SERVICE BULLETIN No.1170

COACH BUS MODEL	: T2145 and C2045
BULLETIN TYPE	: Service Information
MANUAL SECTION	: Exhaust system
DATE	: January 25, 2006
SUBJECT	: Detroit Diesel 60 Series engine with EGR – valve control lines and exhaust down pipe
TERMS & CONDITIONS	: No claims will be accepted with reference to this Bulletin.

Figure 1: Interference between exhaust down pipe (1) and EGR hydraulic lines (2) (C2045 with Detroit Diesel shown)

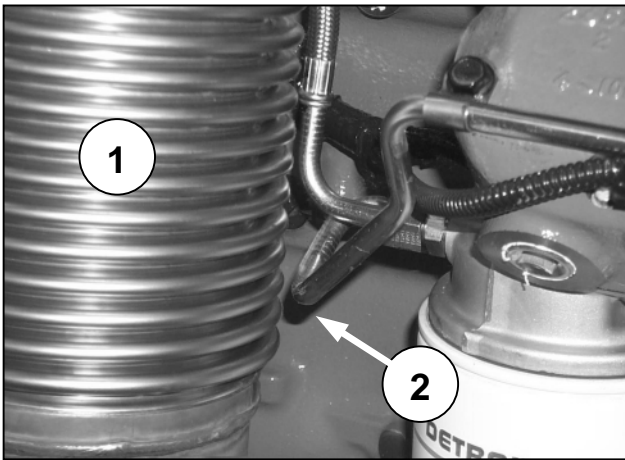
1. Detroit Diesel have replaced the pneumatically operated exhaust gas recirculation valve (EGR) by a hydraulically operated one. The change included a routing of the control lines, which is different to that for the pneumatically operated valve. As a result, the new line installation showed interference with the exhaust down pipe (see Figure 1, overleaf).
2. To address the issue, different solutions have been applied to T2145 and C2045 units, and to current production and field coaches respectively.
The purpose of this Bulletin is to summarize these solutions and provide service technicians guidance on part selection in order to assist them while carrying out exhaust system repair. Installation recommendations have also been included.

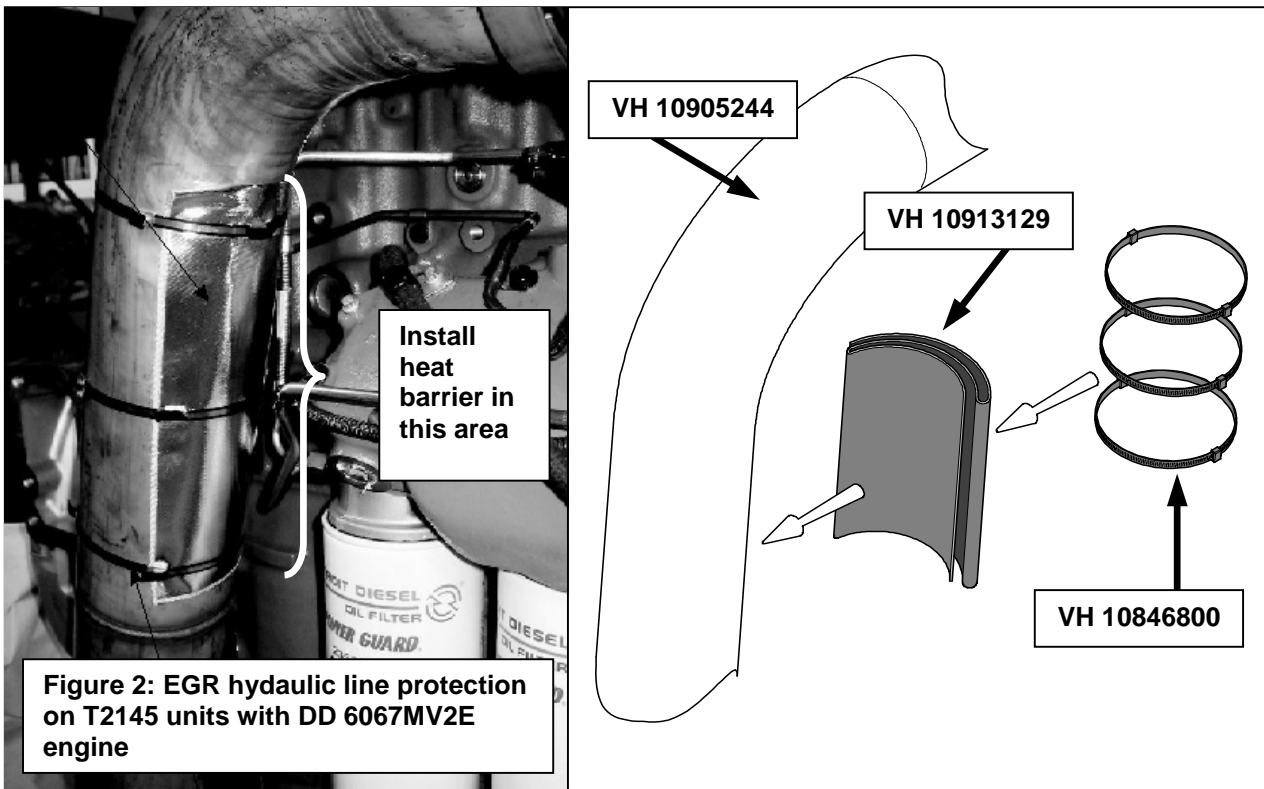
- To protect the EGR hydraulic lines against exhaust heat, an additional 3-layer heat barrier has been installed between the down pipe and the lines (see Figure 2). The barrier is secured to the down pipe with stainless steel tie wraps. No further changes have been made to the installation.
- Whenever the down pipe is reinstalled or replaced during repair, the heat barrier should also be reinstalled/replaced. Relevant part numbers are provided below.

1. Fold the heat resistant fabric (35 1/2 x 9 inches) to obtain a 9 x 12 inch heat shield.
2. Install the heat shield below the down pipe upper bend of in the area indicated in Figure 2.
3. Secure the shield to the down pipe with stainless steel tie wraps (3 x 2 tie wraps).
4. Cut and fold back the tie wrap end to secure the cable tie lock.

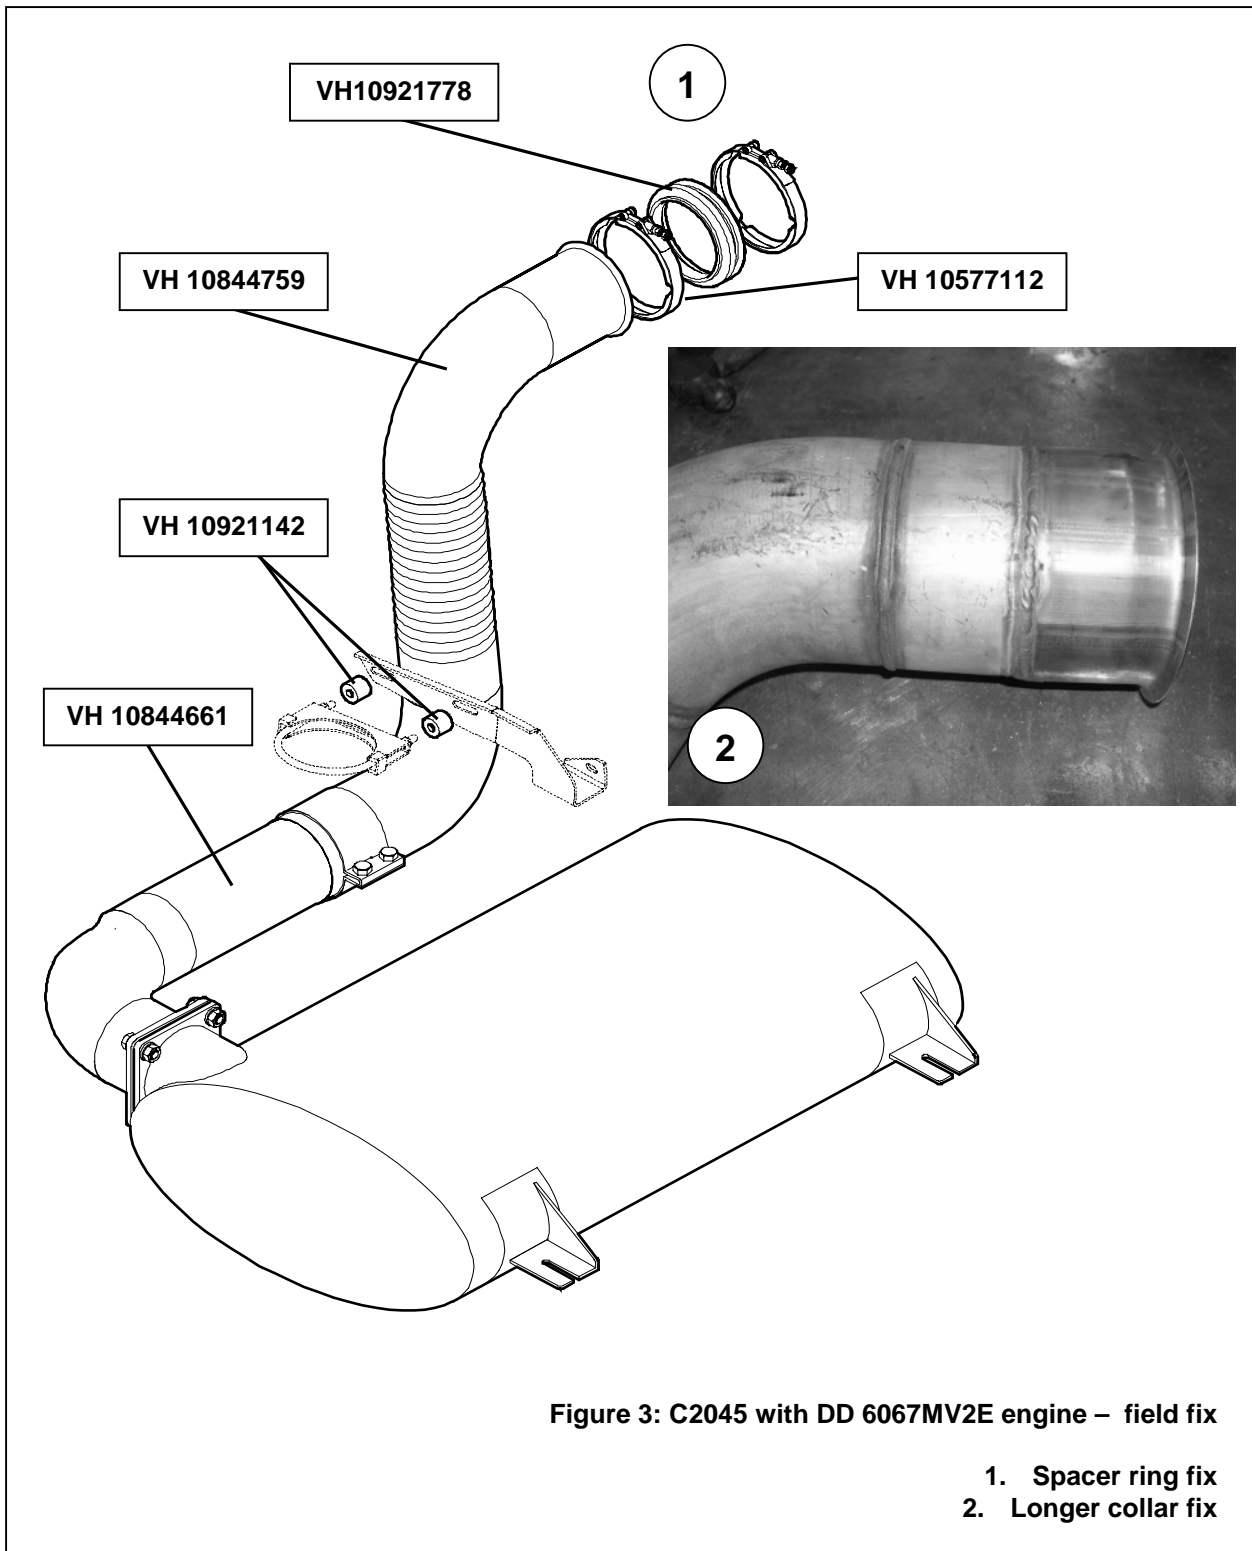
In production, following changes have been made (see Figure 3):

- The upper part of the down pipe VH10844759 has been lengthened by 25/32 inch.
- The down pipe to muffler elbow VH 10844661 has been shortened by 25/32 inch.
- Spacers VH 10921142 have been added between clamp VH 10749062 and down pipe mounting bracket VH 10844572.
- The muffler has been relocated to the original position.

- To protect the EGR hydraulic lines and the compensator, the upper part of the down pipe has been lengthened, either by fitting a 25/32 inch spacer ring between the pipe and the turbo exhaust (see Figure 4.1) or by cutting-off and welding on a longer collar (see Figure 4.2). This moves back the pipe by the same amount and provides sufficient clearance for the EGR lines.
The muffler has been moved back also, to ensure stress-free installation of the down pipe.
- Whenever a down pipe fitted with a spacer ring is replaced by the new and longer factory item, the ring and accompanying clamp should be discarded.
Repositioning of the muffler may be necessary.

Figure 4: Installation sleeve

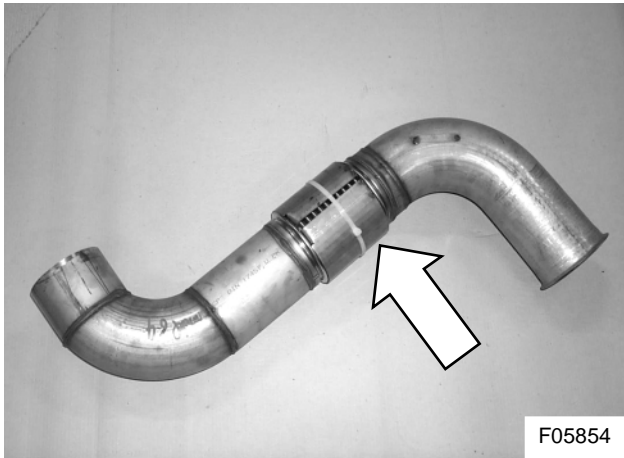
CAUTION: Do not remove the installation sleeve around the compensator shown in Figure 4 until all parts have been installed.

CAUTION: Always fit the installation sleeve around the compensator when welding is done to the downpipe.
